Addendum #10

East Lake Community Center Renovations

CONTRACT NO. Y-17-005

M4.1
 MECHANICAL ROOF PLAN

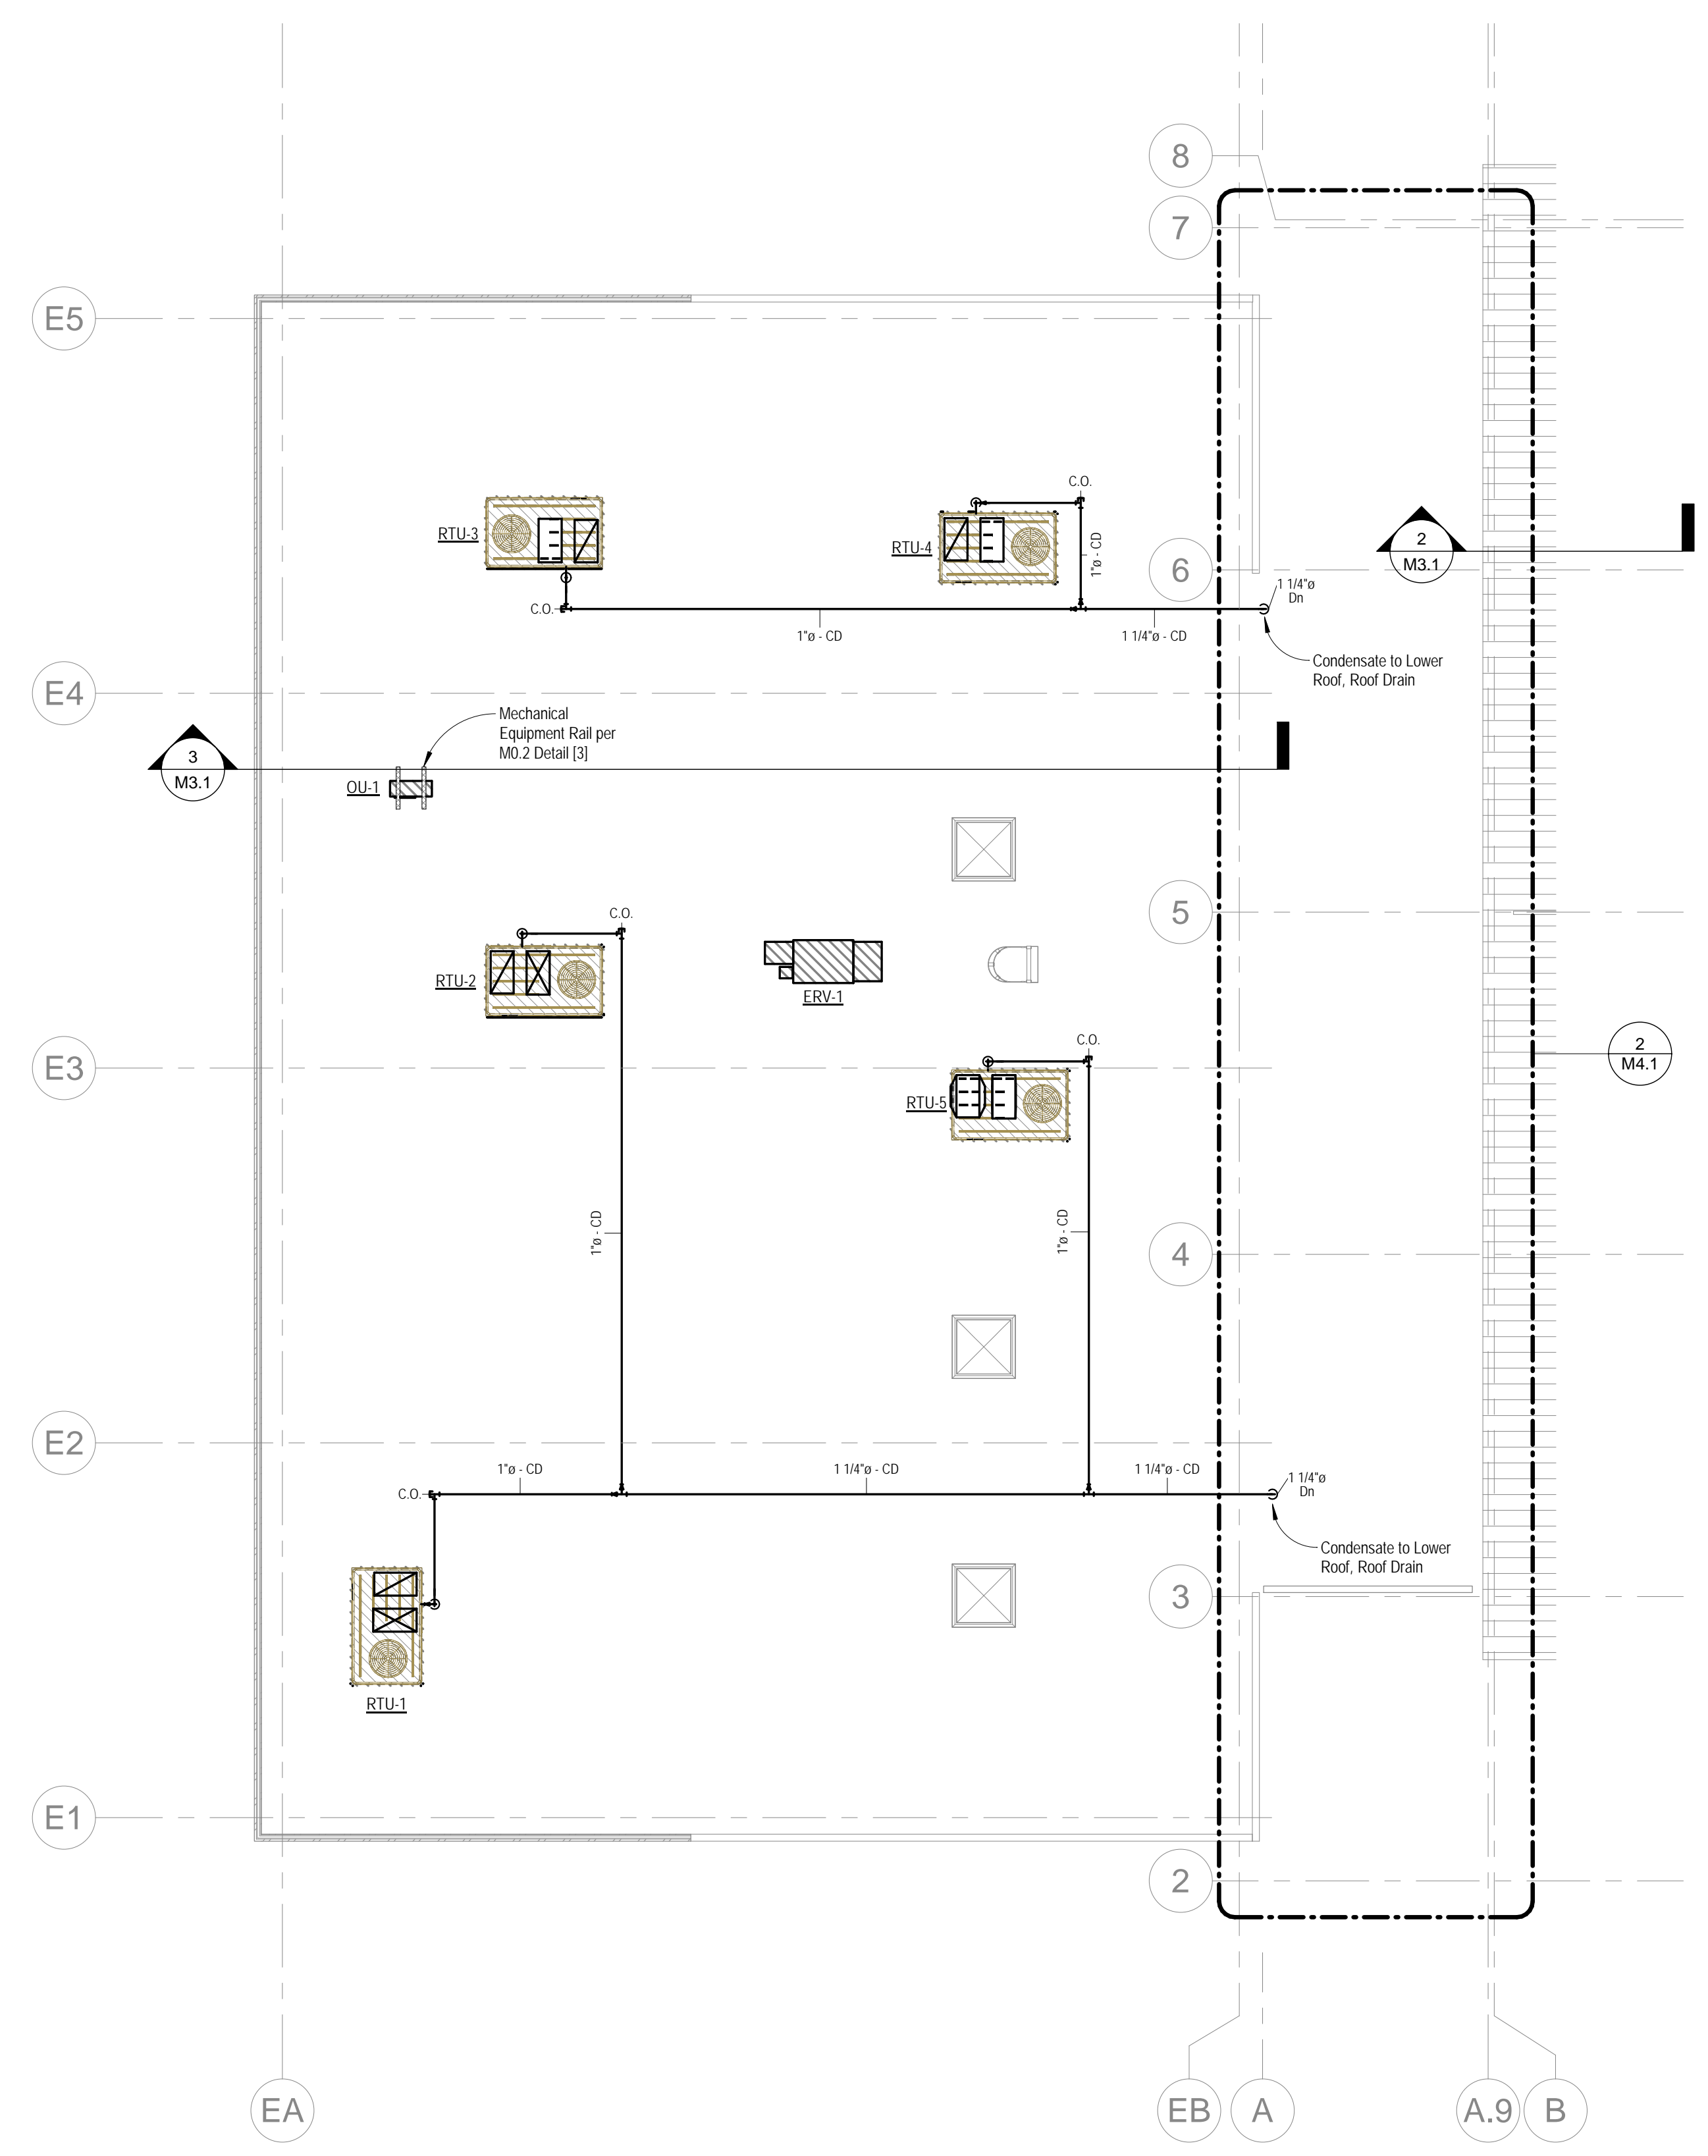
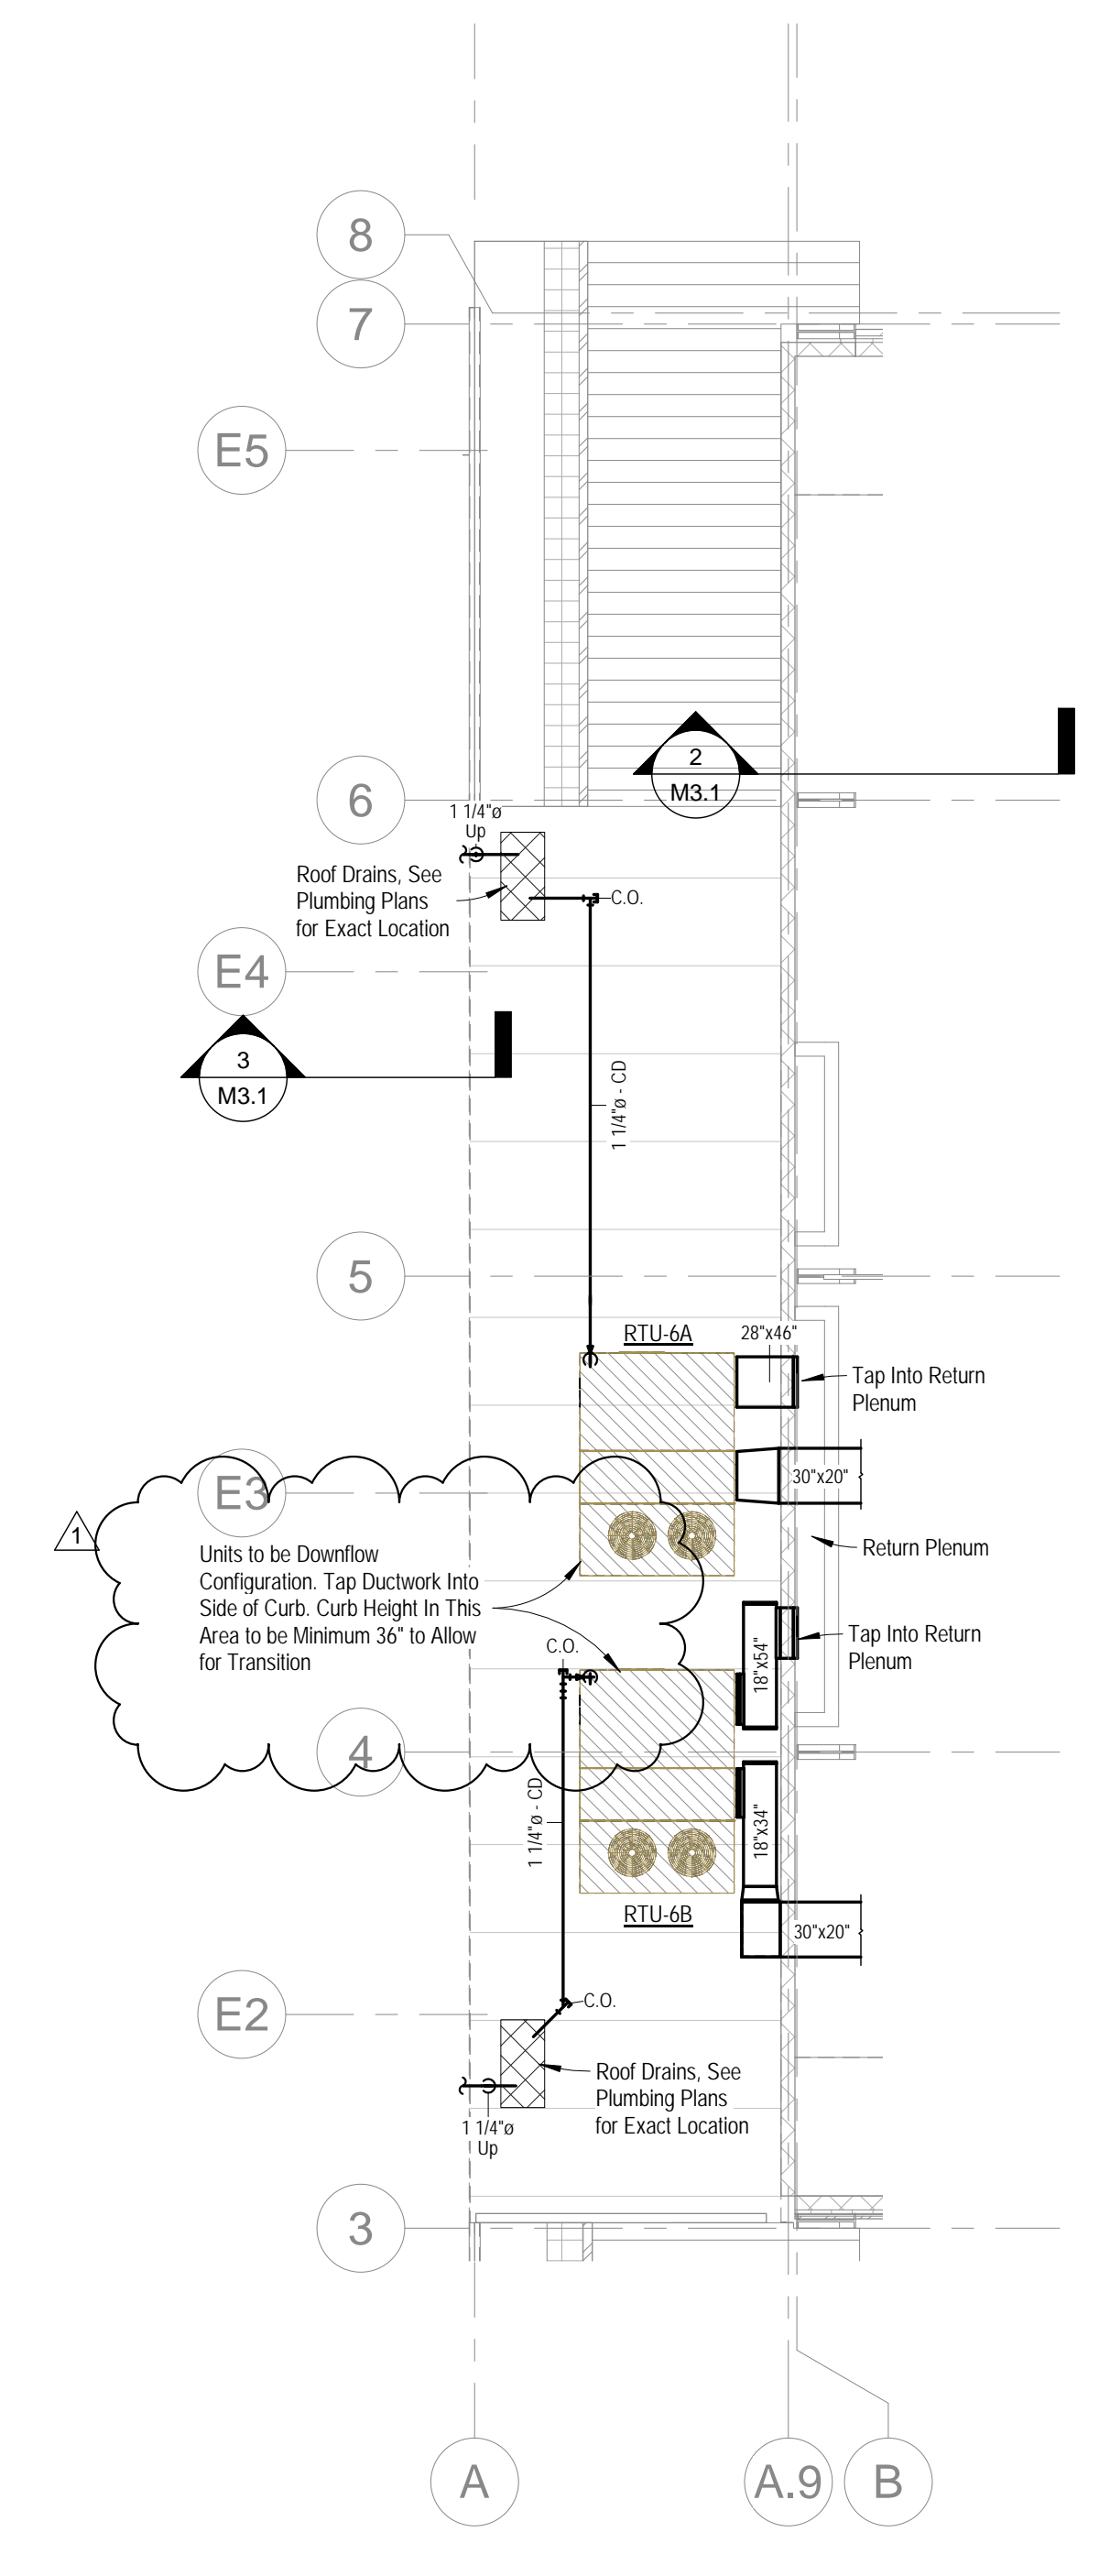
- Added note detailing unit flow configuration and curb minimum height.

M8.1 MECHANICAL SCHEDULES & NOTES

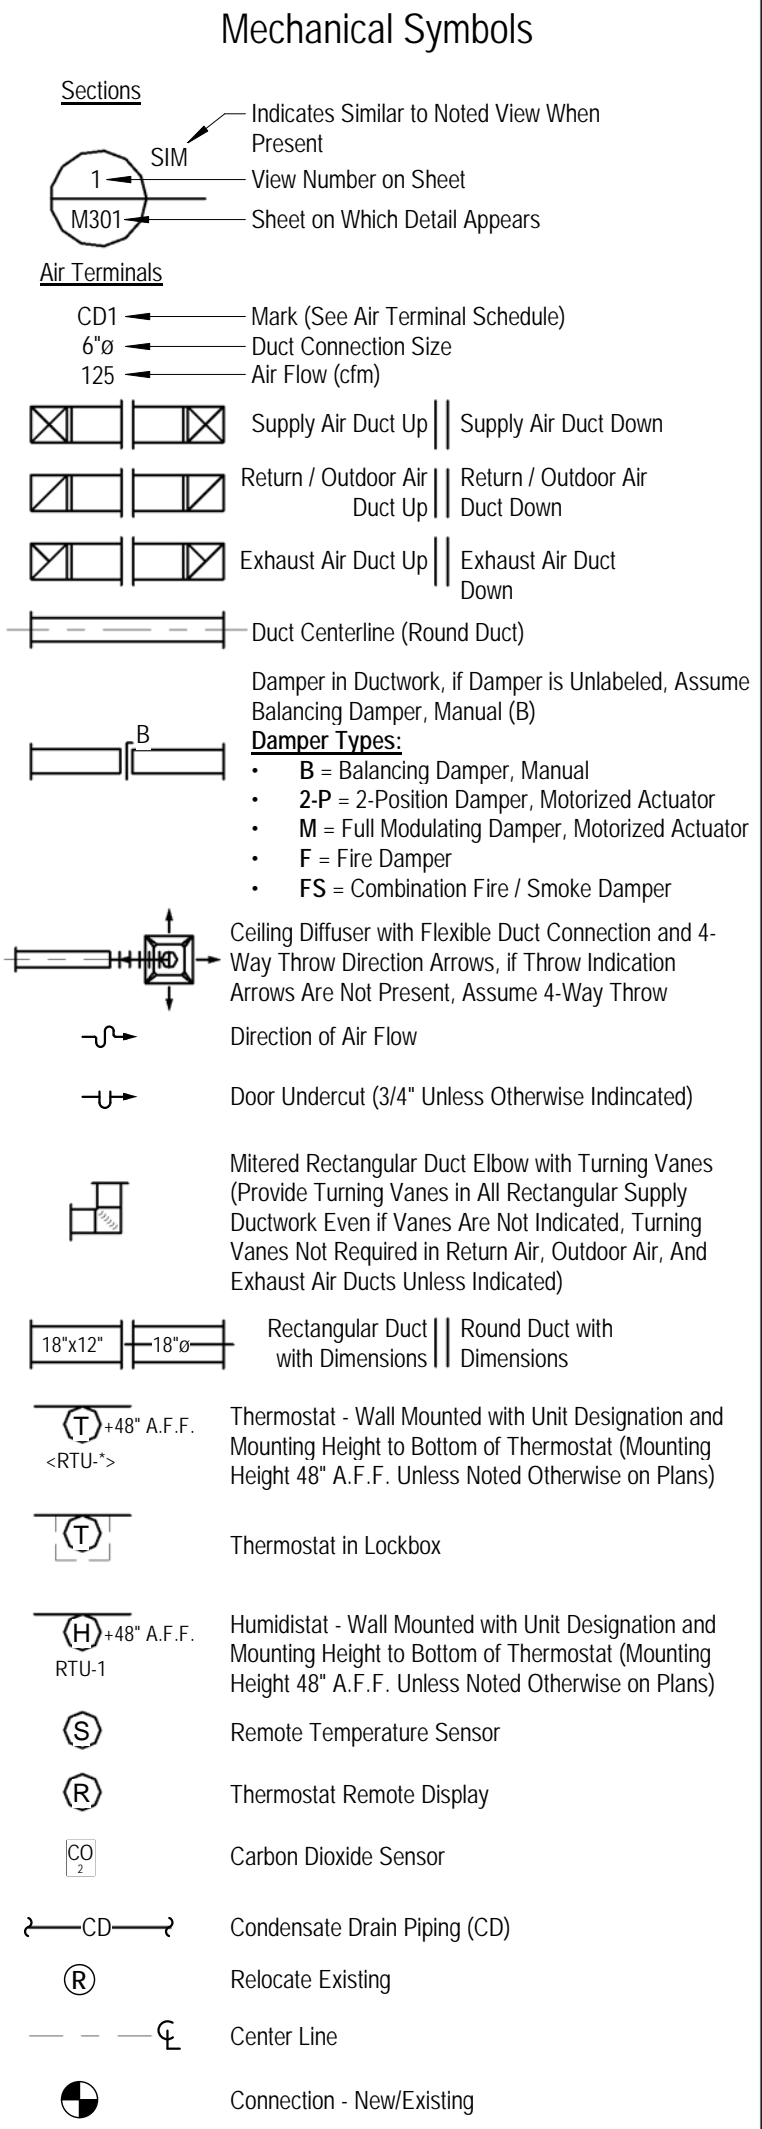
- RTU-6a/b Fan E.S.P. increased to account for static drop in curb. Note added describing new roof curb height restrictions.
